Summary Presentation on the Proposed MetroLink Route and its Potential Effect on AerCap House

Hines Real Estate Submission

Section 2.1 MetroLink Building Damage Assessment of AerCap House

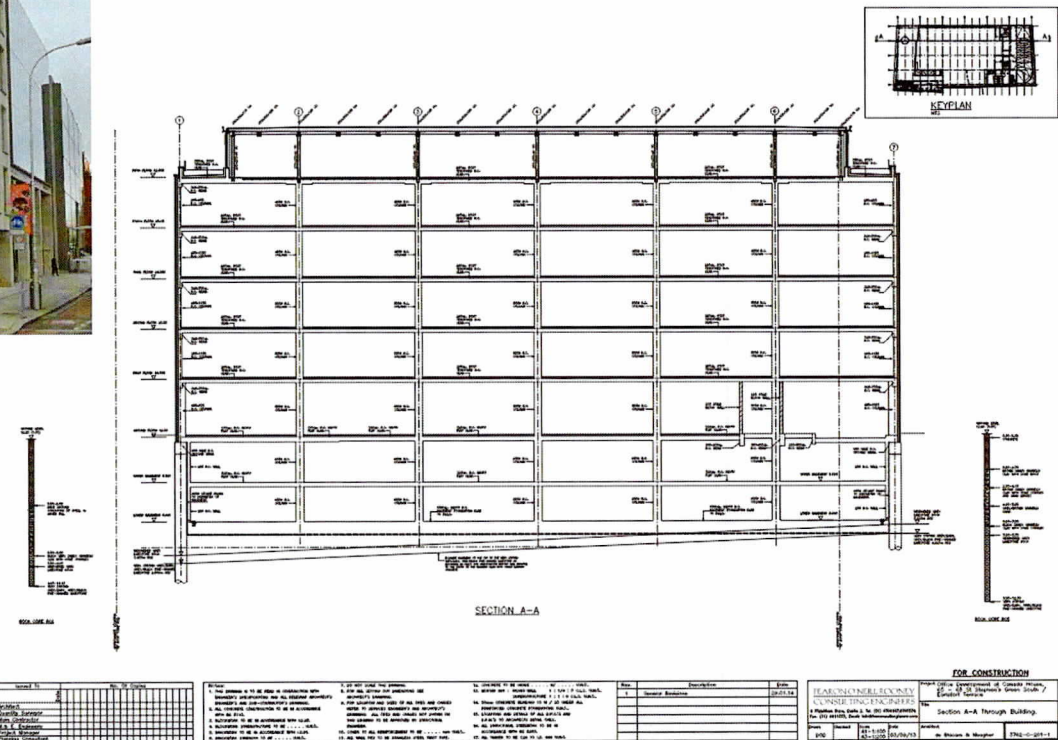
The proximity of the proposed tunnel to the existing structure has not been correctly assessed or considered by the Jacob/IDOM team. I have reviewed the Building Damage Report ("the BDR") produced by Jacob/IDOM, which was included in Appendix A5.17 of the Environmental Impact Assessment Report ("the EIAR"), and I believe the building that has been assessed (reference AB-37 in the EIAR, table 5.4) incorrectly describes the property as a five-storey building and with no reference to a basement. This description does not correctly represent AerCap House, which is a six-storey building with a two-storey basement structure. The description describes one of the buildings on the site that was demolished (Canada House) prior to the construction of AerCap House.

The Building (AB-37) described in the BDR is a five-storey building. It is clearly incorrect and does not correspond with AerCap House, which has been constructed on this plot. The findings of the BDR concerning the Building Damage Categorisation are incorrect as the data used was not checked or verified.

The empirical degree of damage thresholds in TII risk classification table in the BDR are for masonry structures and do not take account of the main characteristics of the AerCap building, including the basement waterproofing system and façade construction.

Therefore, the expected Category of Damage present by Jacob/IDOM cannot be relied upon, which, if followed, would result in damage to our Client's building.
